**Planning Application for Residential Development of 43 Dwellings  
on Land at Oakhurst Rise, Cheltenham (Ref: 20/00683/OUT)**

**LAND OFF OAKHURST RISE, KINGS  
CHURCH, CHELTENHAM  
(UPDATED SCHEME)**

**PROPOSED SITE ACCESS & INTERNAL  
ADOPTABLE ROAD LAYOUT**

**STAGE 1  
ROAD SAFETY AUDIT REPORT &  
MOBILITY AUDIT**

SCALE @ A1:	DATE:	DRAWN:	CHECKED:	APPROVED:
1:250	06.04.20	LG	MP	MP
JOB NO:	DRAWING NO:	REVISION:		
CTP-16-332	SP07	E

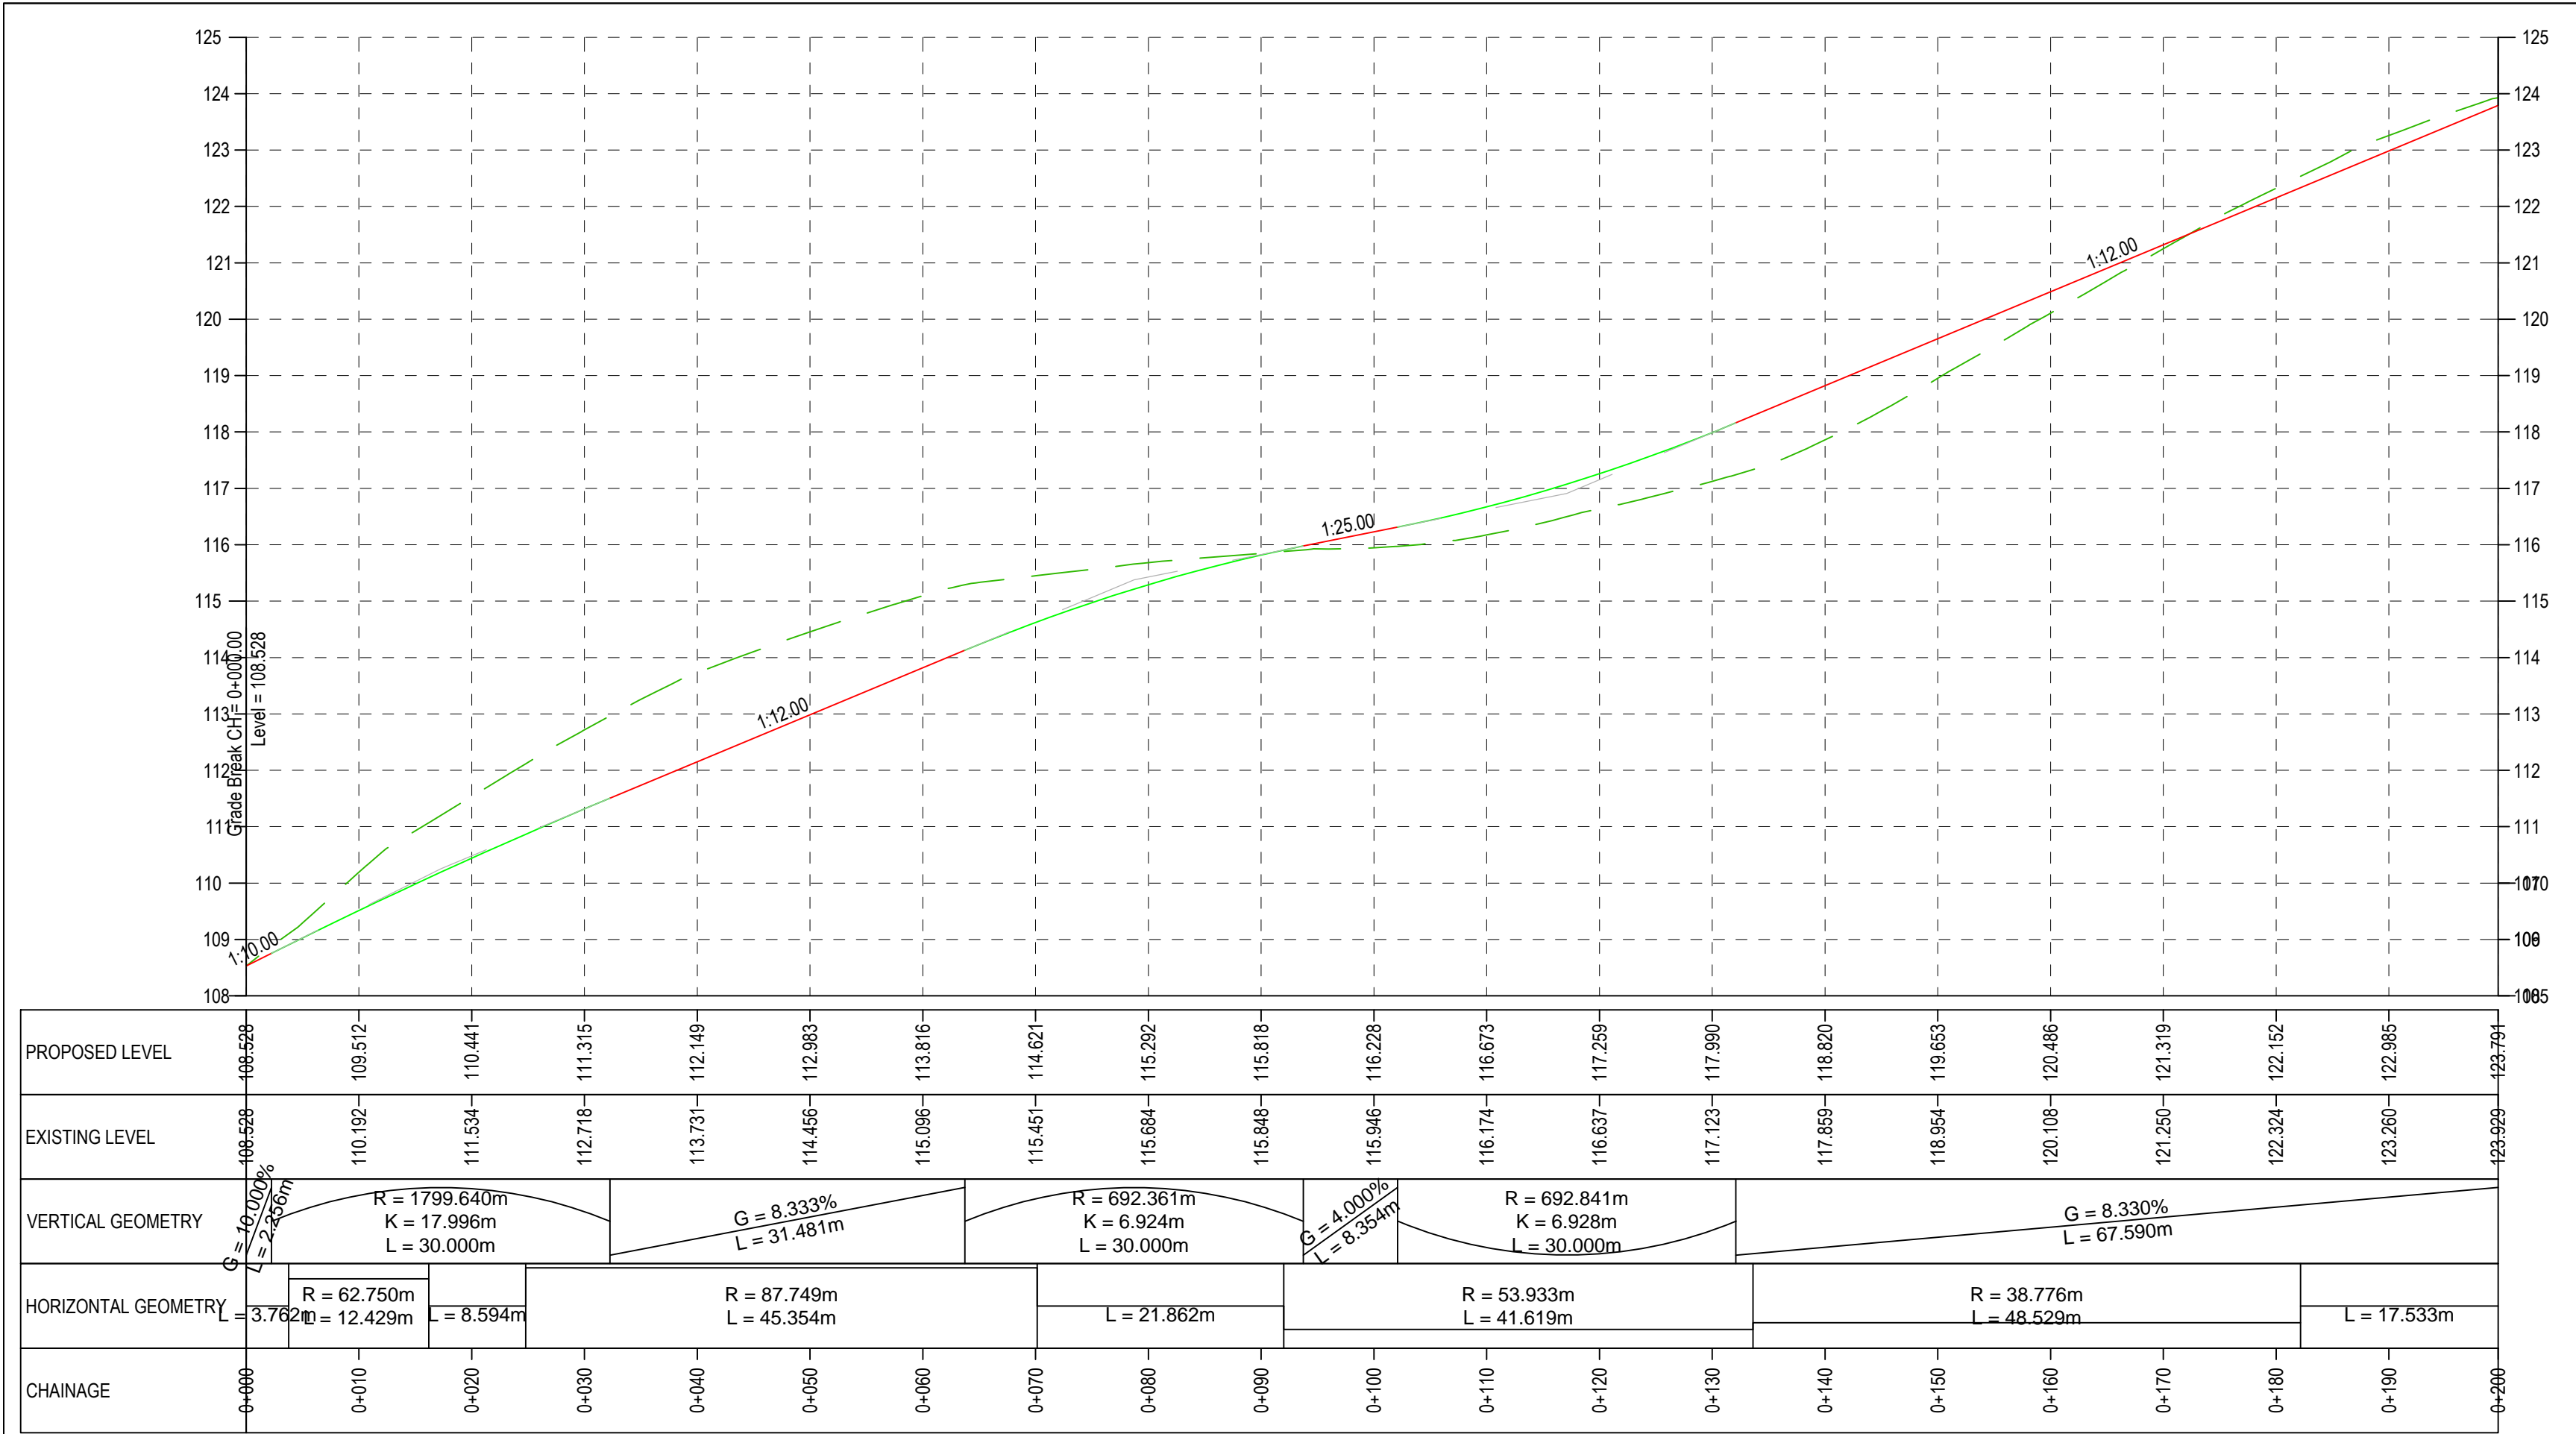
E	08.06.20	Masterplan amended following GCC Highways comments	LG	MP
D	20.05.20	Amended to include latest masterplan	LG	MP
C	24.04.20	Amended to include revised masterplan	LG	MP
B	23.04.20	Amended to include revised masterplan	LG	MP
A	16.04.20	Updated to include revised masterplan	LG	MP
Rev	Date	Details	Drawn by	Checked by

CLIENT:	WMCL			
PROJECT: Land off Oakhurst Rise, Charlton Kings				
TITLE: Internal Site Road Swept Path Analysis - Refuse Vehicle/Estate Car				
STATUS: <b>INFORMATION</b>				
SCALE @ A1: 1:500	DATE: 07.12.16	DRAWN: LG	CHECKED: MP	APPROVED: MP
JOB NO: CTP-16-332	DRAWING NO: SP01		REVISION: W

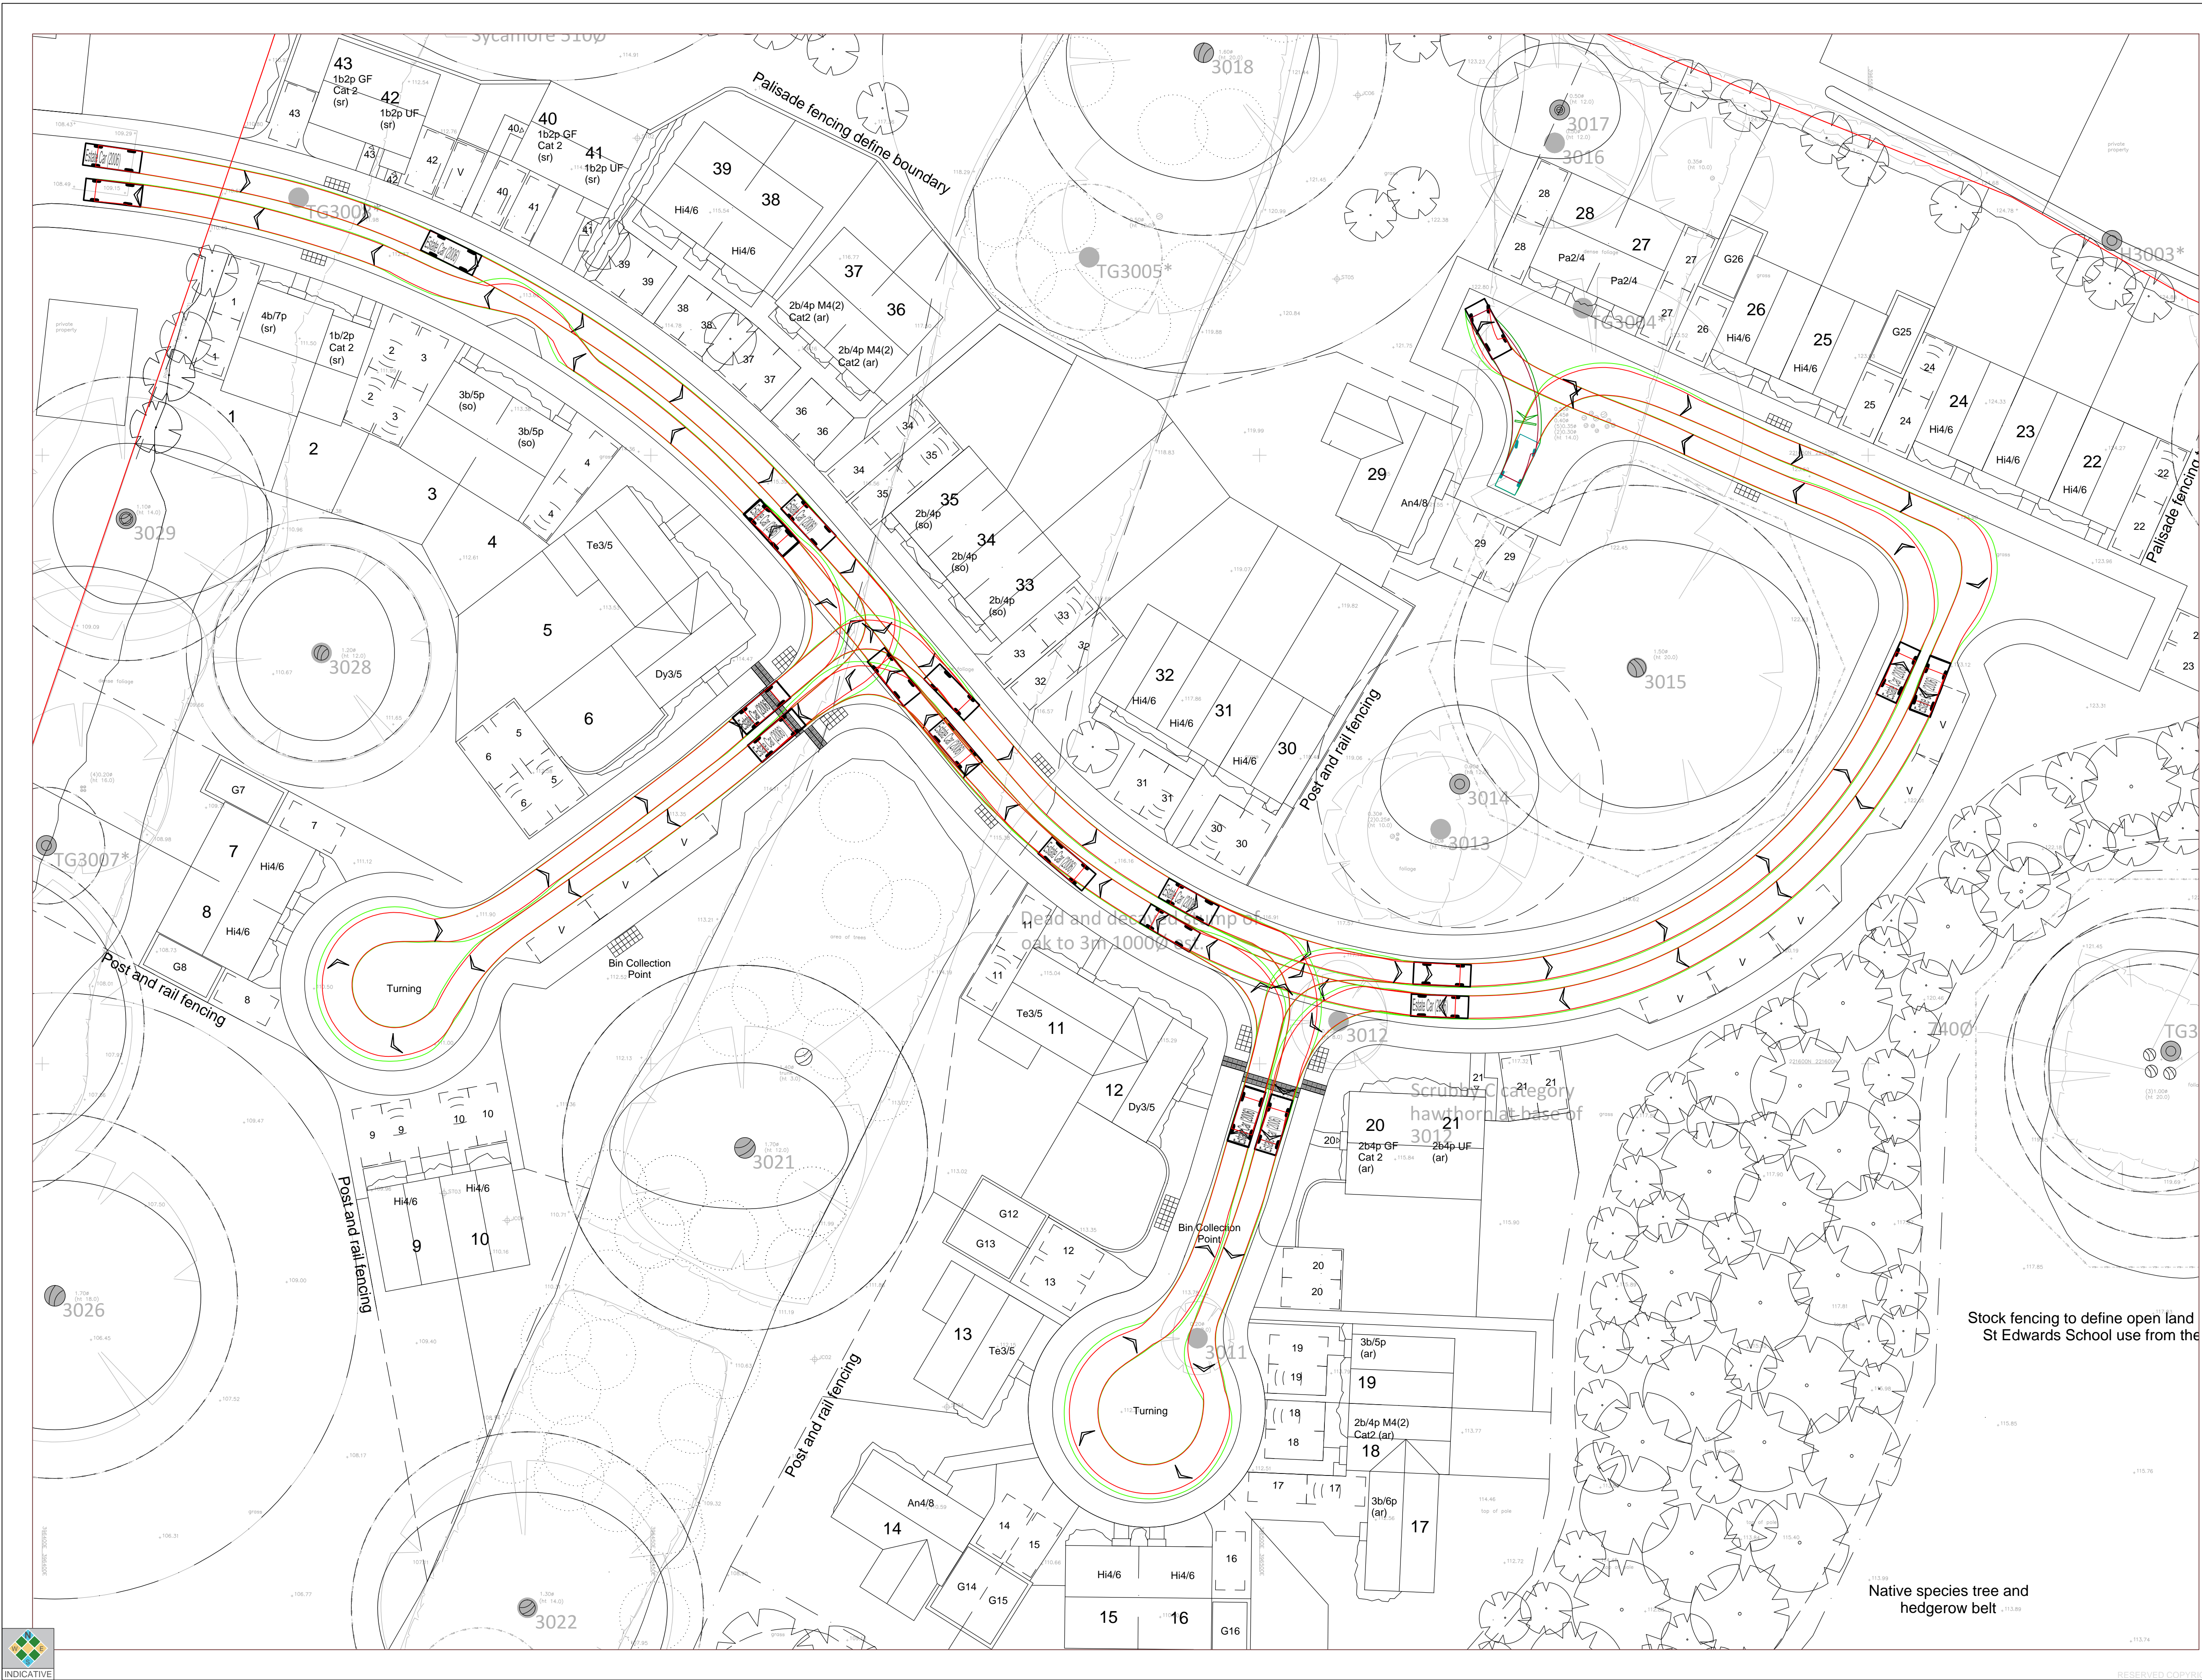
W	02.06.20	Masterplan updated and build-out added	LG	MP
V	20.05.20	Amended to include latest masterplan	LG	MP
U	24.04.20	Amended to include latest masterplan	LG	MP
T	23.04.20	Amended to include latest masterplan	LG	MP
S	15.04.20	Updated to include latest masterplan	LG	MP
R	06.04.20	Revised scheme	LG	MP
Rev	Date	Details	Drawn by	Checked by

CLIENT:	WMCL			
PROJECT:	Land off Oakhurst Rise, Charlton Kings			
TITLE:	Internal Site Road Swept Path Analysis - Estate Car			
STATUS:	INFORMATION			
SCALE @ A1:	DATE:	DRAWN:	CHECKED:	APPROVED:
1:250	07.12.16	LG	MP	MP
JOB NO:	DRAWING NO:		REVISION:	
CTP-16-332	SP02		T

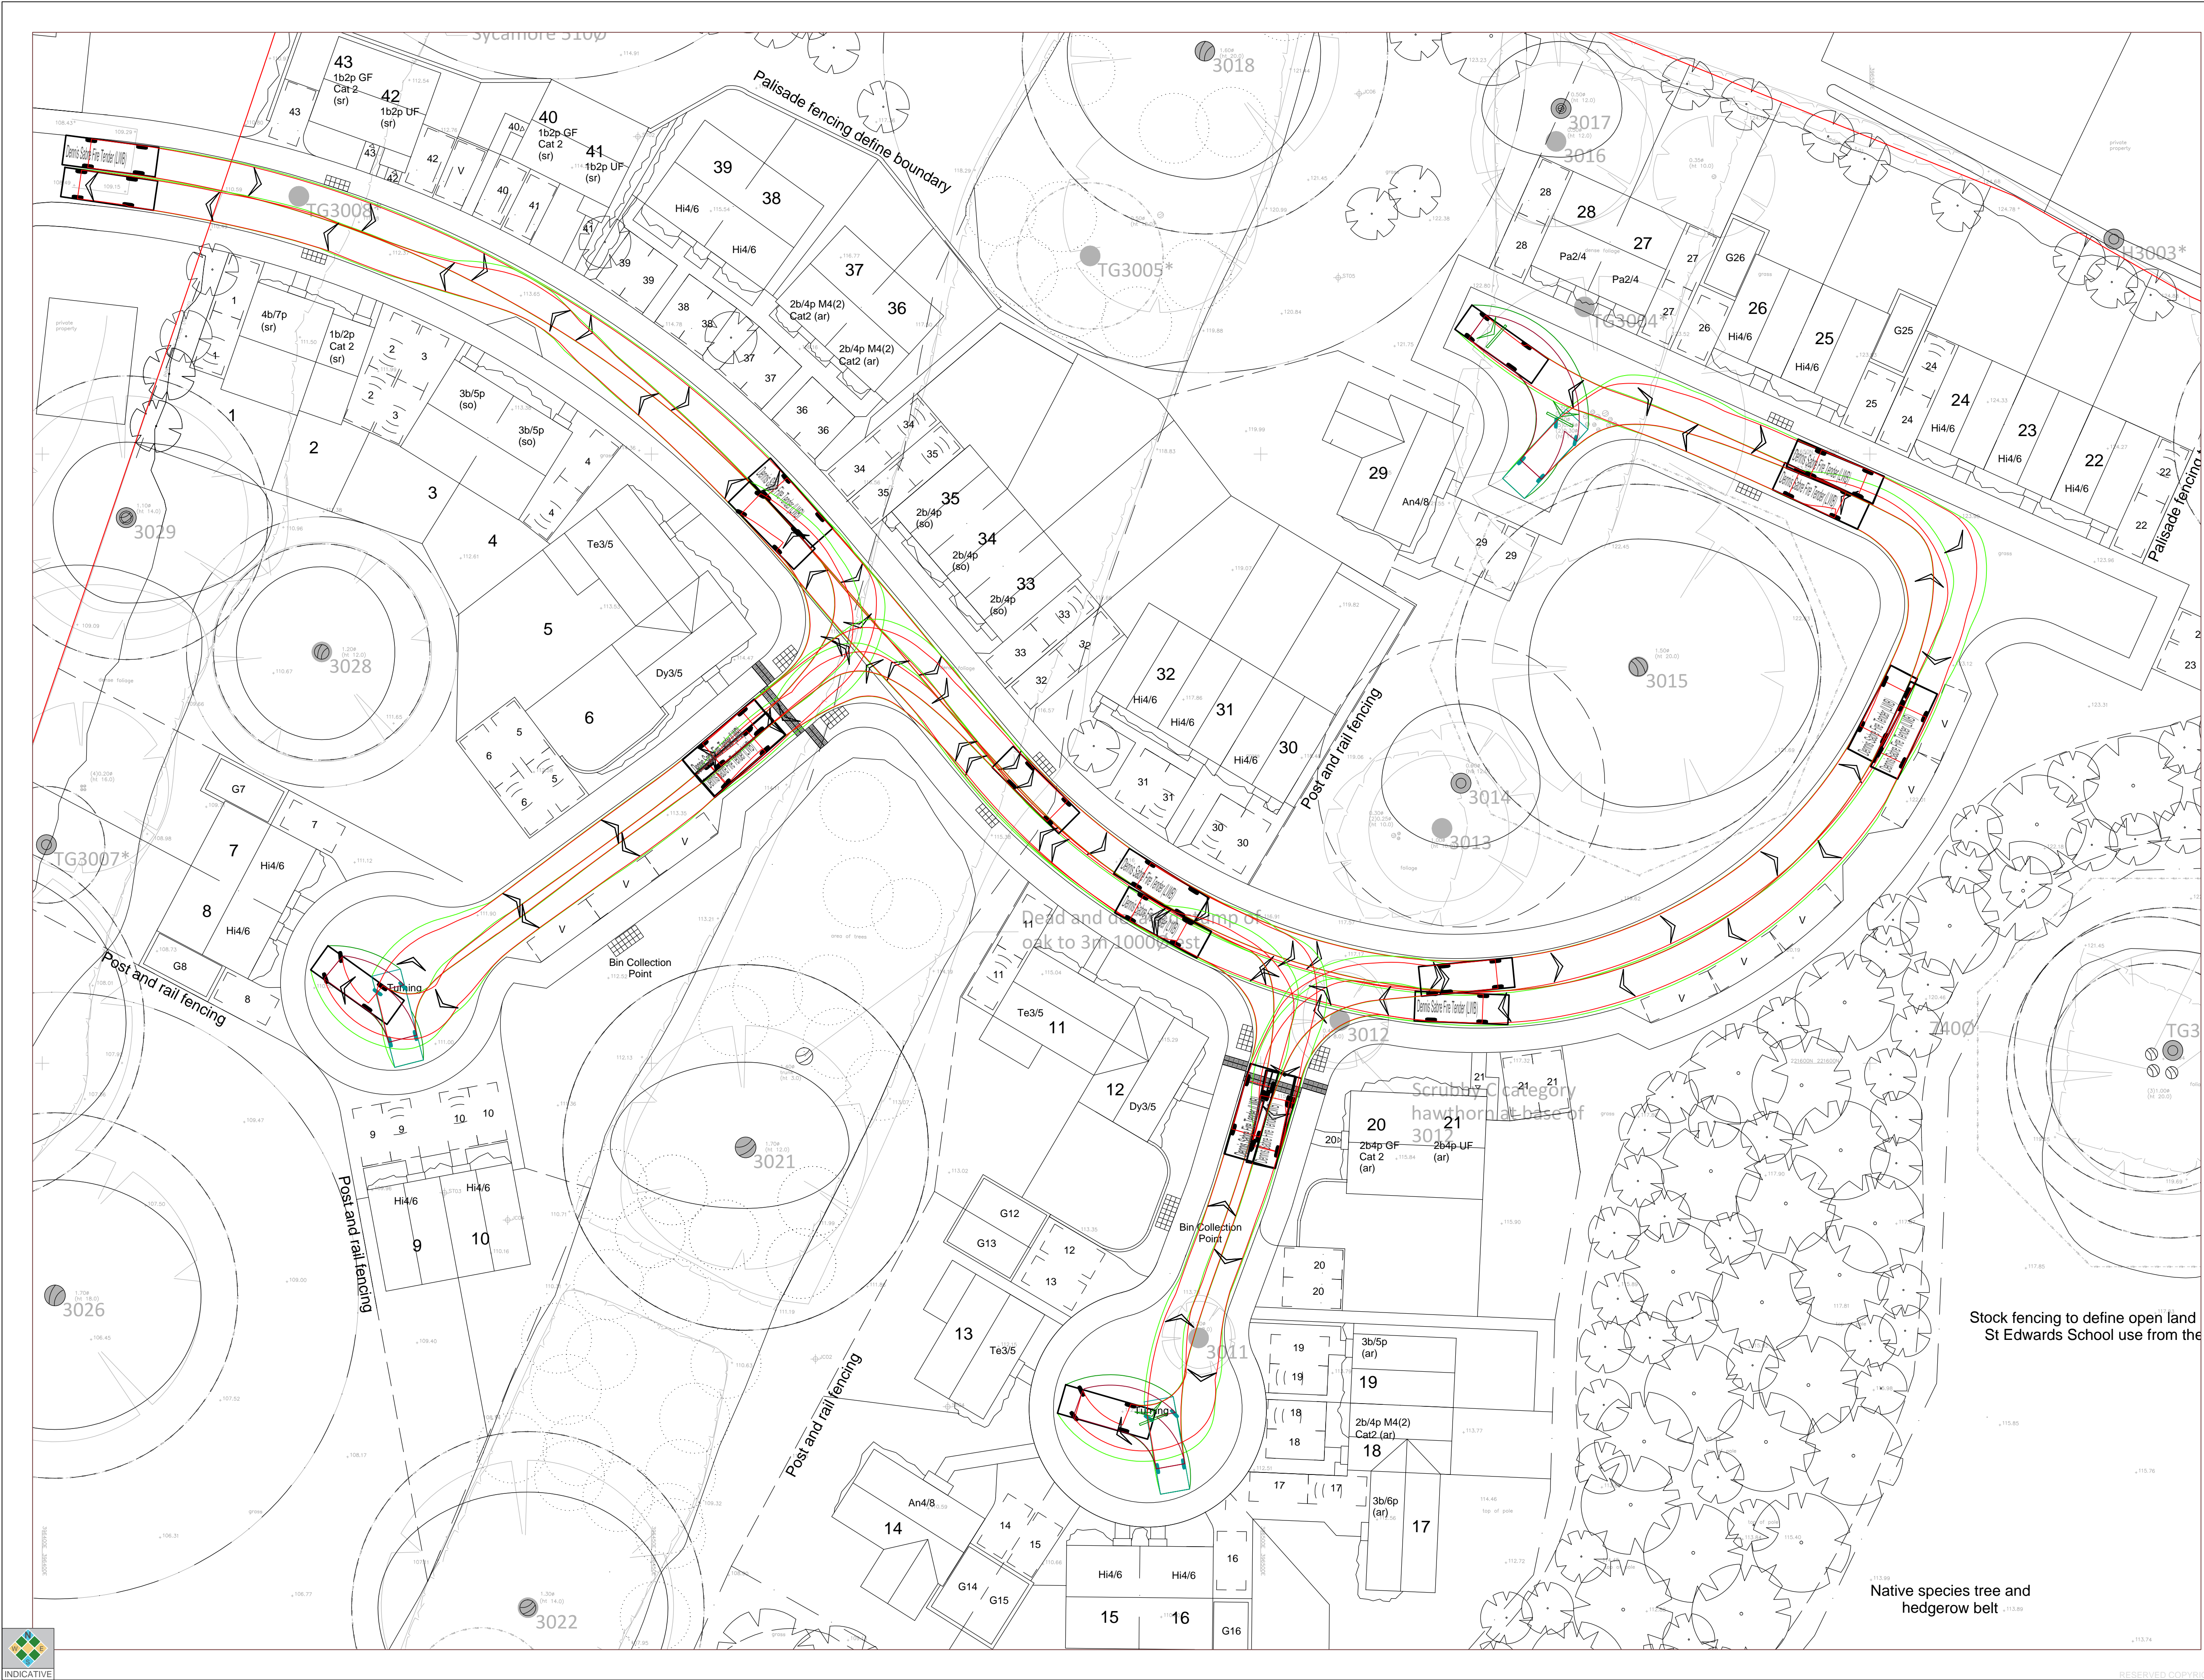
T	02.06.20	Masterplan amended and build-out added	LG	MP
S	20.05.20	Amended to include latest masterplan	LG	MP
Q	23.04.20	Amended to include latest masterplan	LG	MP
P	15.04.20	Updated to include revised layout	LG	MP
N	06.04.20	Revised scheme	LG	MP
Rev	Date	Details	Drawn by	Checked by
